Consumers  
Power  
Company

September 10, 1981

MIDLAND PROJECT  
MIDLAND DOCKET NOS 50-329, 50-330  
FOLLOW-UP RESPONSE TO OPEN ITEMS OF DRAFT SER SECTION 5.2.2  
FILE: 0505.805 SERIAL: 13785

Enclosures (1) Follow-up Response to Open Item 2(a) of Draft SER  
Section 5.2.2

FIGURE 2  
OCONEE 1 - TRIP #21

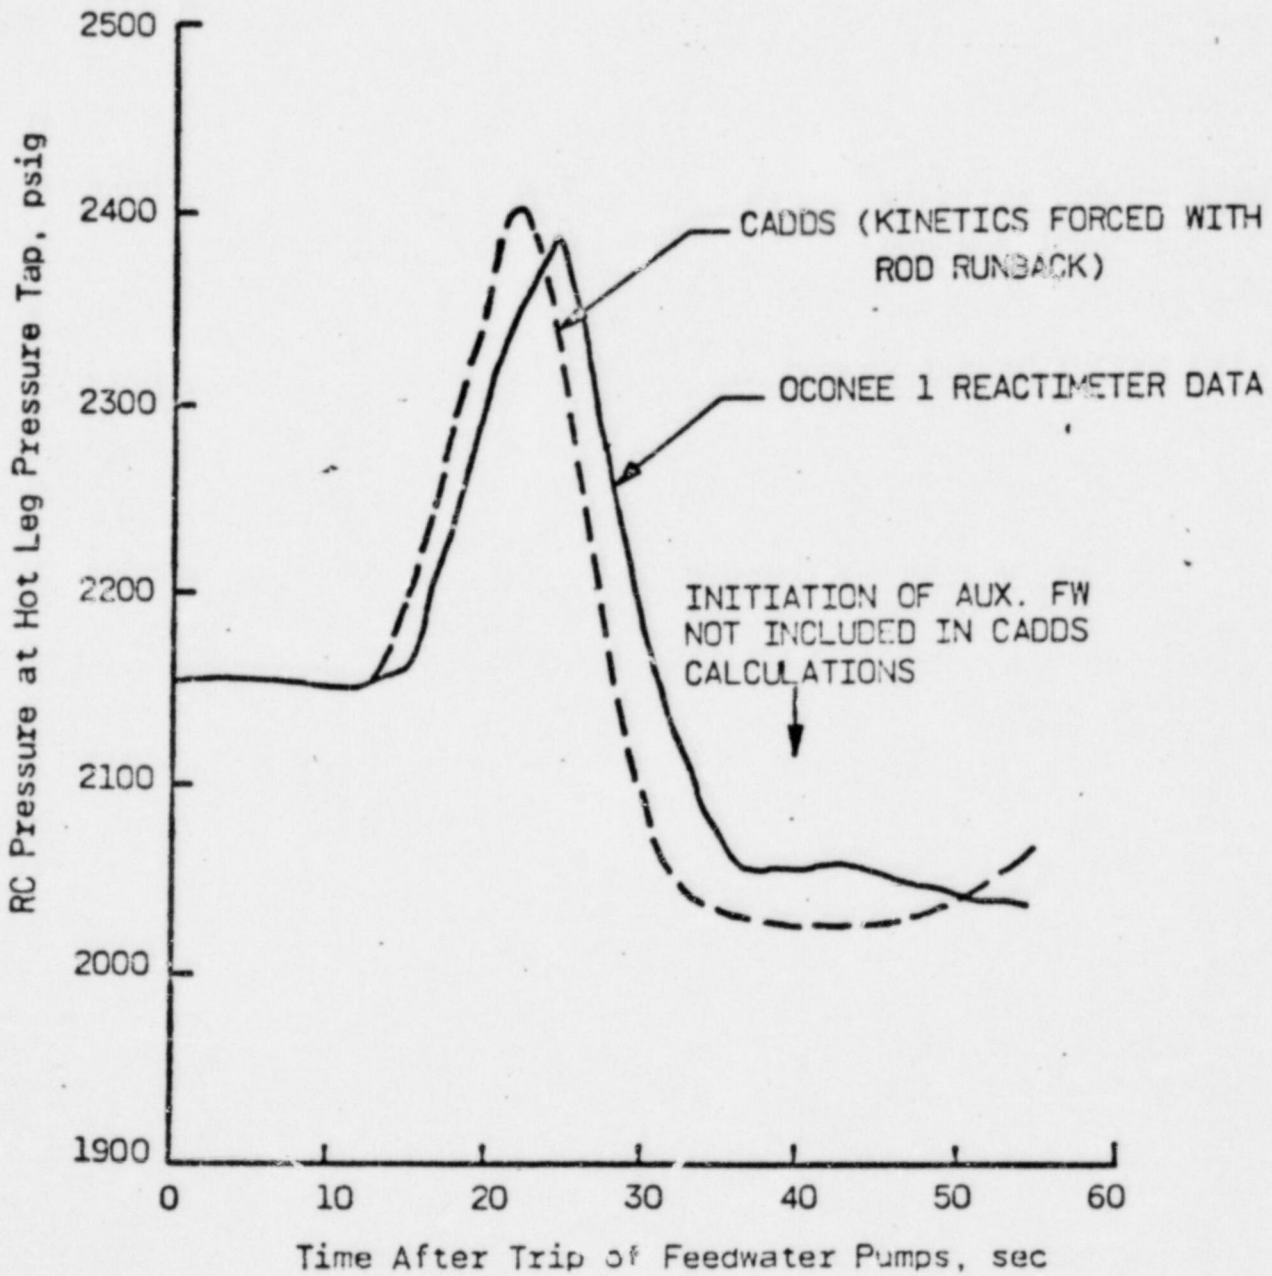
Figure 4. All measured data was recorded at 3 second intervals, so the response times can only be approximated. A comparison of the measured and CADDSS calculated responses are shown in Figures 2, 3, and 4. With the exception of the power peak just prior to the reactor trip, the CADDSS calculated results agree very well with the recorded responses. Differences in peak power may be attributable to the moderator coefficient used and NI calibration.

FIGURE 4  
OCONEE 1 - TRIP #21

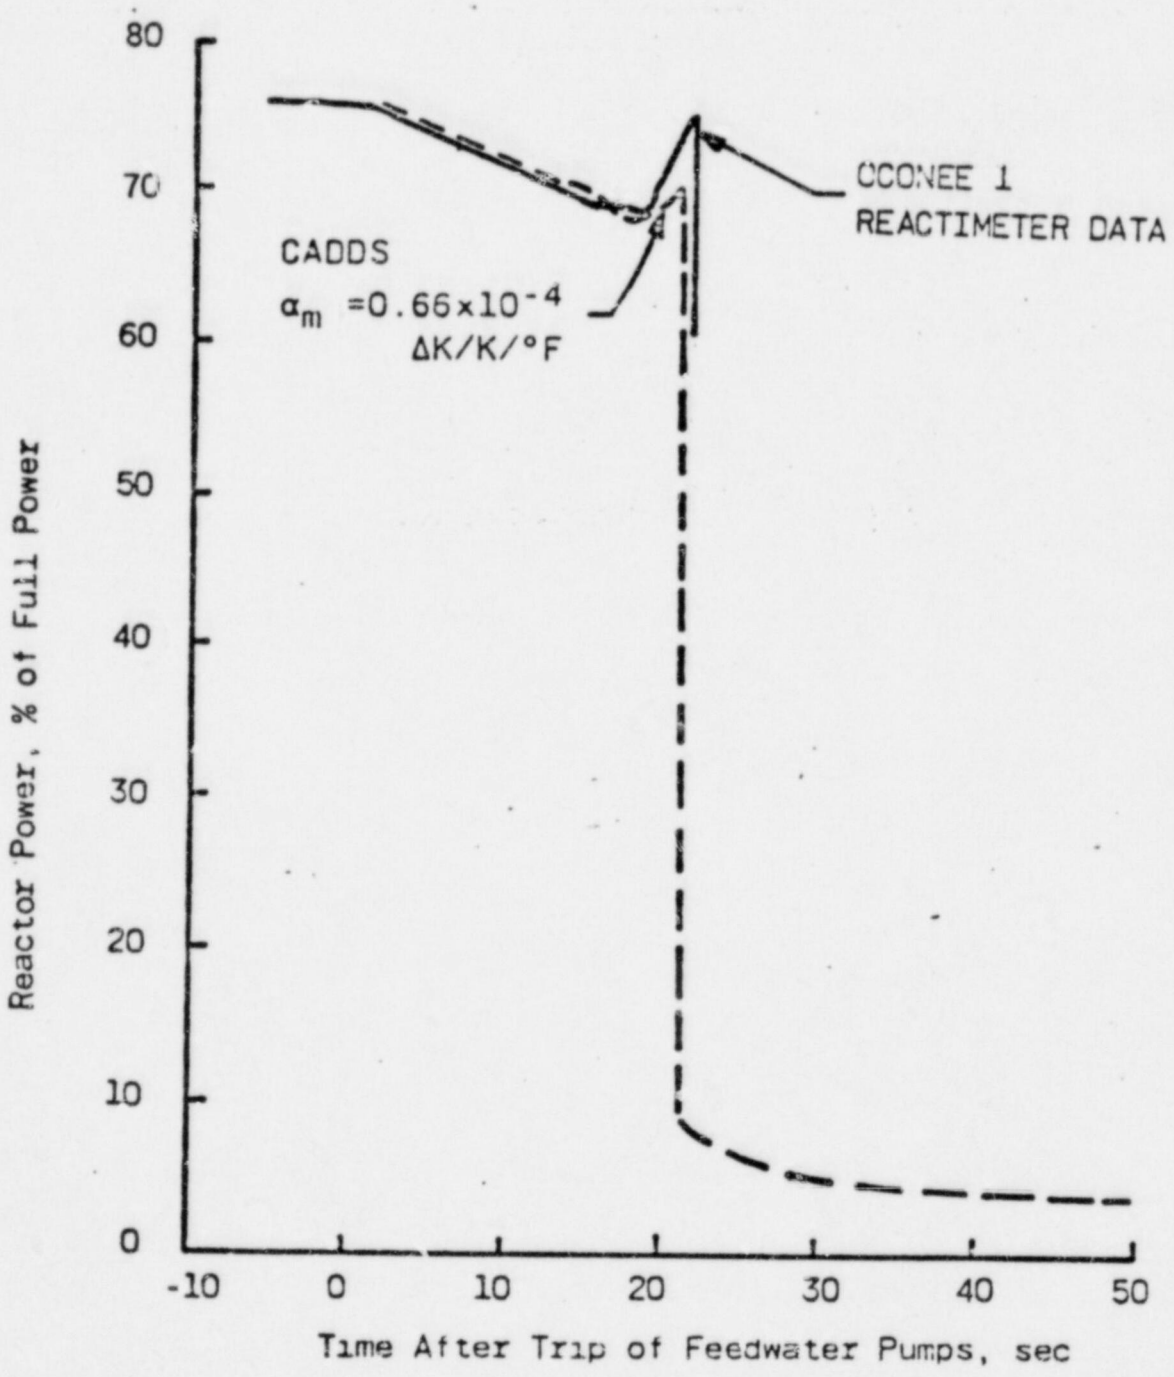
Due to a malfunction in the speed controller in the "B" main feedwater pump, a sequence of events was initiated which resulted in the "A" Main Feedwater Pump (MFDWP) tripping due to the loss of the auxiliary oil pump, and the "B" MFDWP tripping on high discharge pressure. This caused a turbine trip (immediately) which resulted in a secondary side pressure surge due to the closing of the turbine stop valves. This is shown in Figure 1. The RC pressure and temperature increased (see Figures 2 and 3) due to the reduction in steam flow and the loss of feedwater. The reactor tripped on high RC pressure approximately 20 seconds after the start of the transient. The reactor started a power runback due to the loss of feedwater, and peak prior to the high RC pressure trip via the positive moderator coefficient as seen in

FIGURE 5  
TMI-1 GENERATOR TRIP @ 96% POWER

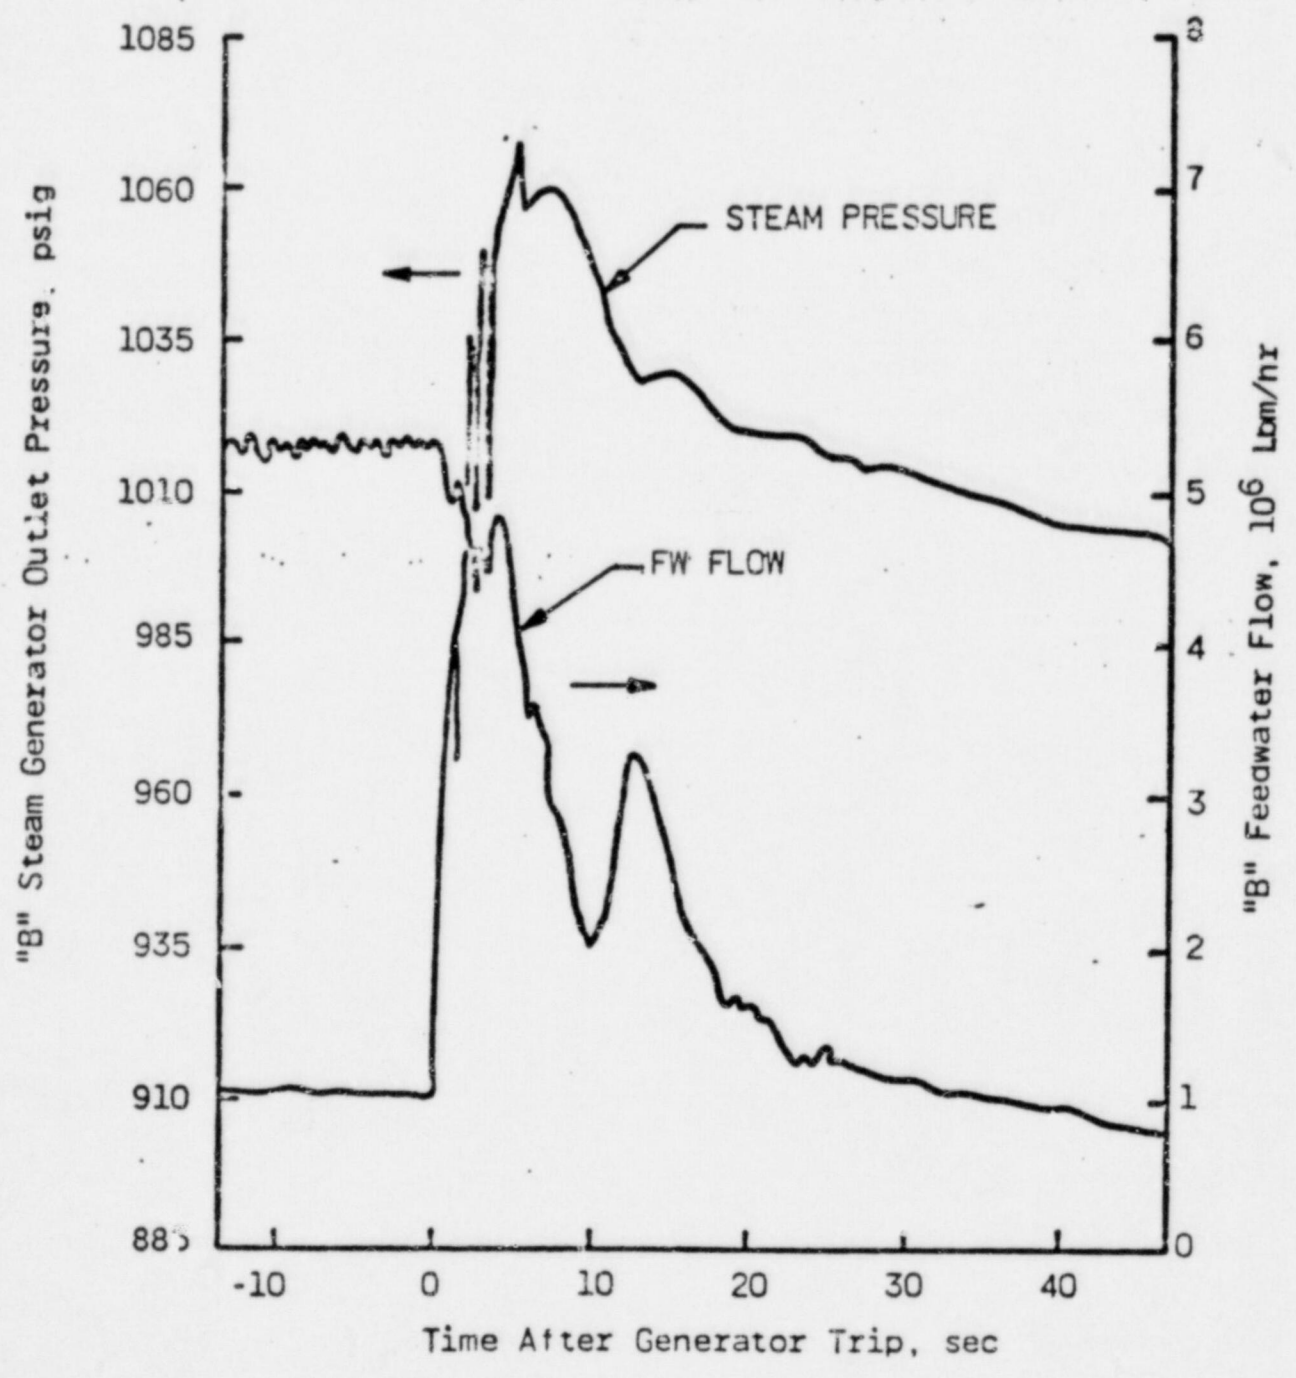
A planned unit generator trip transient was initiated at Three Mile Island Unit 1 by opening the breakers while the reactor was operating at 96% FP. The loss of load caused the turbine to overspeed and initiate closing of the turbine stop valves. The removal of steam flow to the turbine initiated a pressure rise on the secondary side to the code safety value of 1065 psia in approximately 4.5 seconds. A feedwater pump speed "kicker" initiated by the ICS, upon a turbine trip, helped to keep up the feedwater flow. (See Figure 5 for secondary pressure and feedwater flow response).

FIGURE 6  
TMI-1 GENERATOR TRIP @ 96% POWER

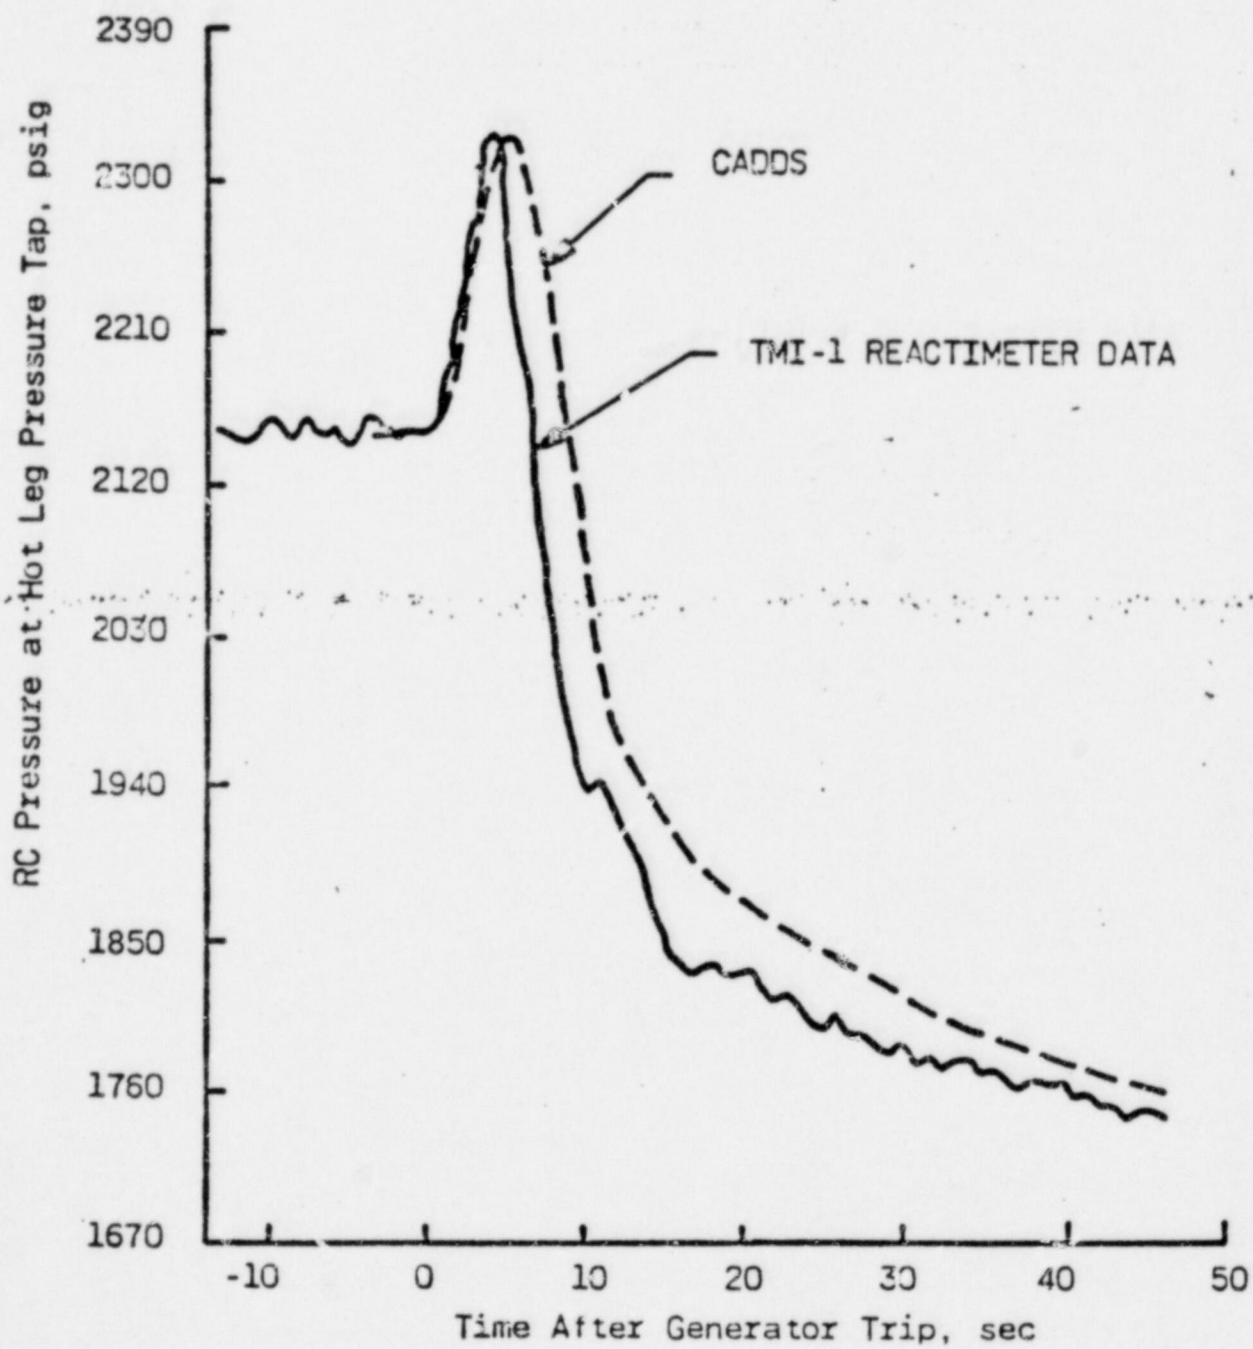
The reduction in steam flow caused a pressure and temperature rise in the reactor coolant system. (See Figure 6 and 7). The ICS started a rod runback (20%/min.) as can be seen in the power response in Figure 8. The reactor tripped on high RC pressure in approximately 3.5 seconds. The change in pressurizer level during the transient is shown in Figure 9. A comparison of the measured and CADDSS calculated responses are indicated in Figures 6, 7, 8, and 9.

The calculated pressure response, as shown in Figure 6, took almost 2 seconds longer than the recorded response to turn fully around. This may be due to the code's inability to respond quickly to the feedwater recovery near the trip time which appears to be responsible for the recorded response.

FIGURE 7  
TMI-1 GENERATOR TRIP @ 96% POWER

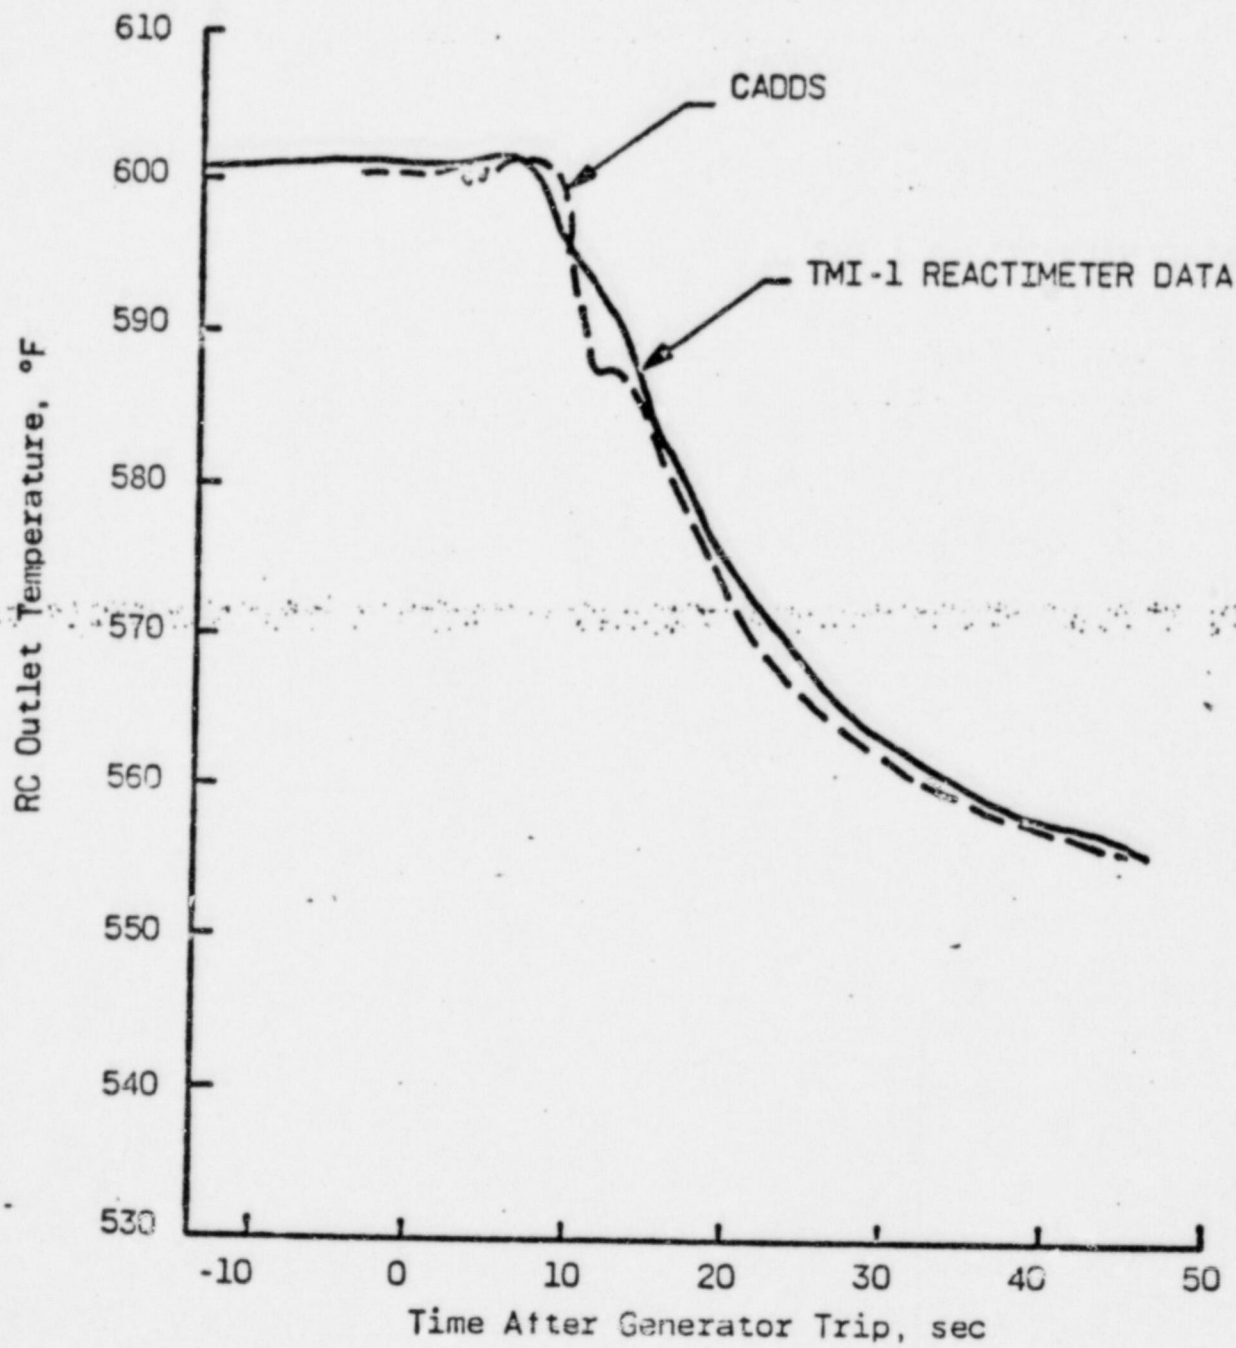
The CADDs calculated RC outlet temperature agrees well with the recorded results (see Figure 7). Delays in temperatures are difficult to account for due to differences in the code nodes and actual sensor locations.

FIGURE 8  
TMI-I GENERATOR TRIP : 96% POWER

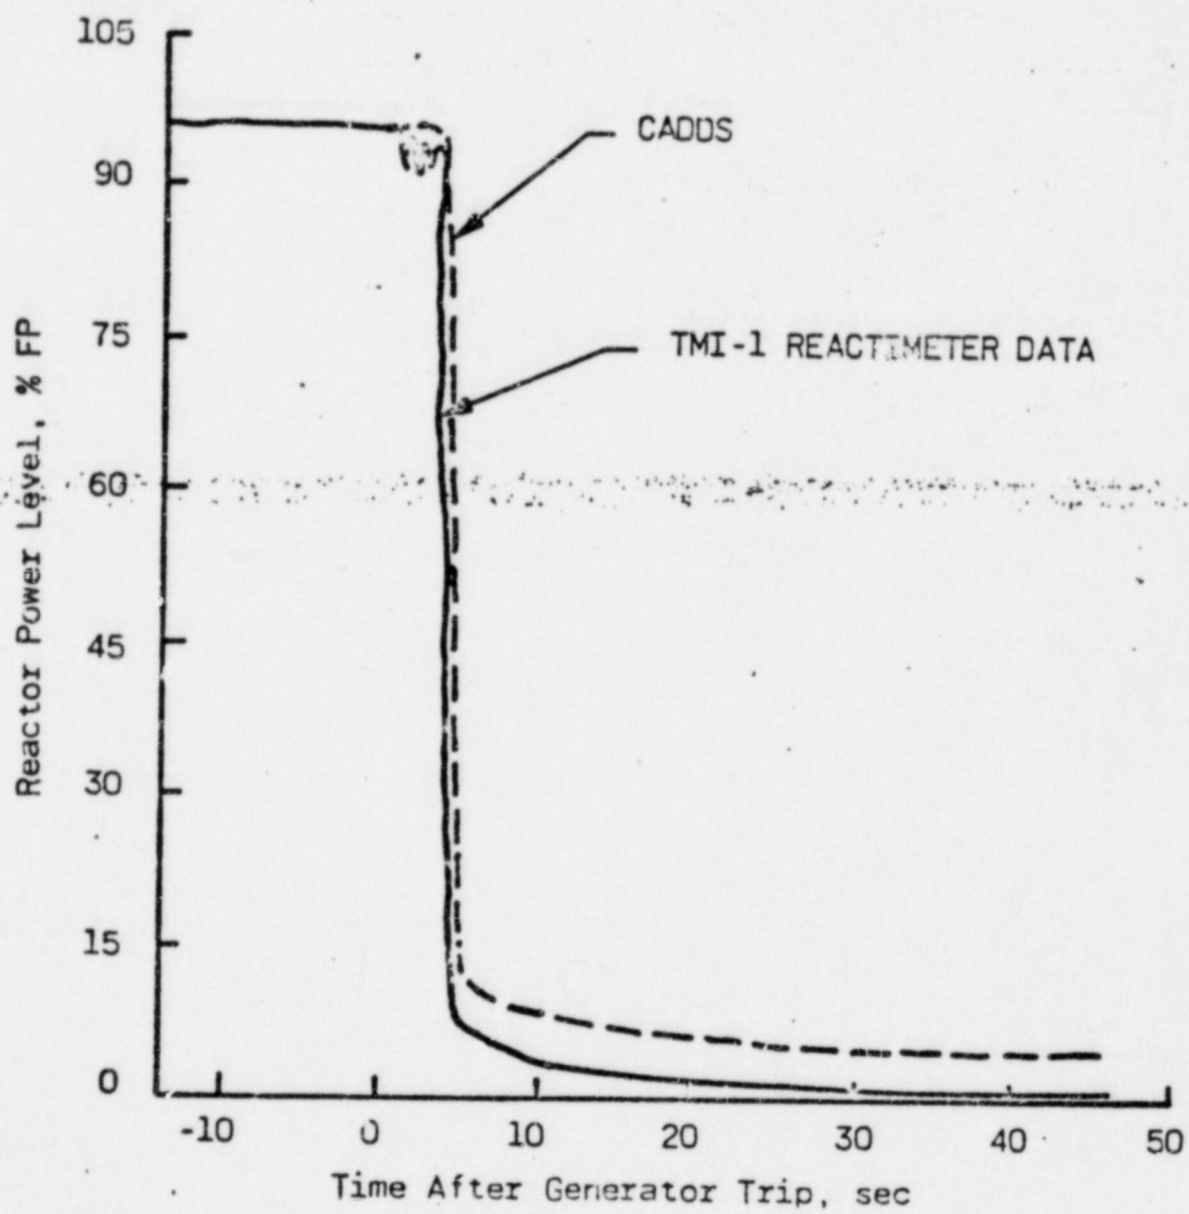
No rod runback was used in the CADDs calculation (Figure 8), since in the 3.5 seconds prior to reactor trip, the power level decreased only ~2% FP, and should have little effect on RC pressure and temperature response. A slightly negative moderator coefficient was estimated for this case based on the initial power level, EFPD, and boron concentration. The calculated effect on the power level was negligible; the measured effect was marked by the rod runback.
